Sling Aircraft (Pty) Ltd
Registration no 2002/022837/07
Approved Maintenance Organisation AMO1264
Manufacturing Organisation M677

NOTIFICATION

#0009

SUBJECT: Static Longitudinal Stability – Permitted Removal of Elevator Centre Balance Weights.
Optional modification to be referred to as “Sling 4 TSi Optional Elevator Centre Balance Weight Removal Modification”

Figure 4 Trim arm with clevis, split pin and pin visible

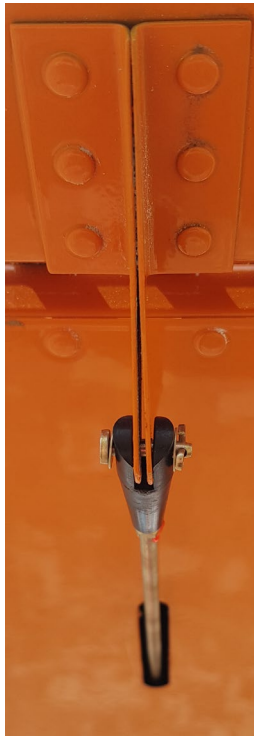
1. Remove the split pin, that secures the clevis/trim tab connecting pin, with long/needle-nose pliers.

2. Remove the clevis/trim tab connecting pin.
3. Loosen the $\frac{1}{4}$ " nut, with the appropriate wrench, and turn the nut such that there is at least a 10mm gap between the nut and plastic clevis.
